DOSATRON®

UPGRADING FROM D8R TO D8RE OR D40MZ - 40 GPM SERIES

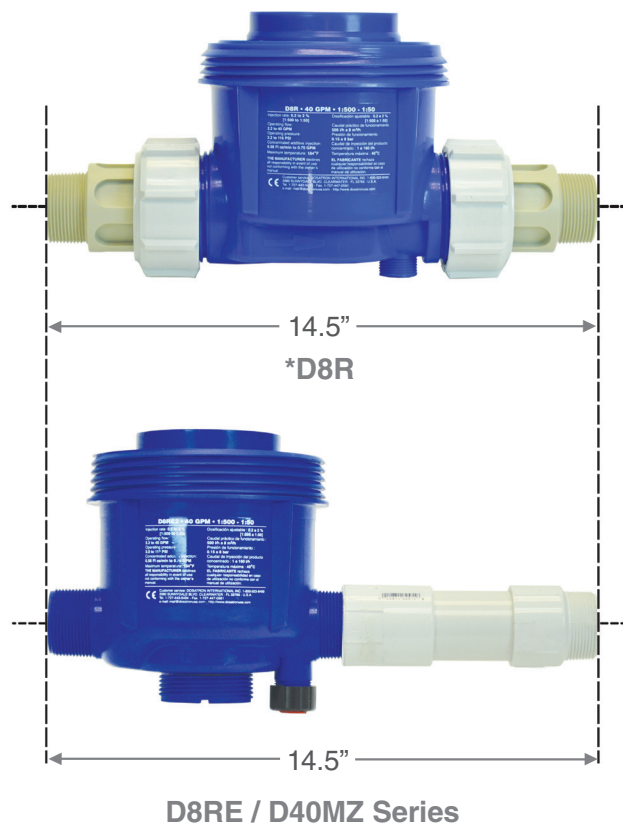
The width on the *D8R and all D8RE / D40MZ Series is different due to the different body styles. There is an easy plumbing option to install your NEW D8RE / D40MZ units to fit in the space of your old *D8R unit

It will require an ADAPTER that consists of:

- A** 1.5" slip x 1.5" female NPT Thread Adapter
- B** Approximately 4.25" to 4.5" section of 1.5" PVC
- C** 1.5" slip x 1.5" male NPT Thread Adapter
- D** PVC glue

- Glue the piece of pipe **B** to the slip side of each fitting **A** and **C**
- Wrap thread tape onto the threaded part of the injector's body
- Screw the new adapter onto the D8RE / D40MZ Series injector body
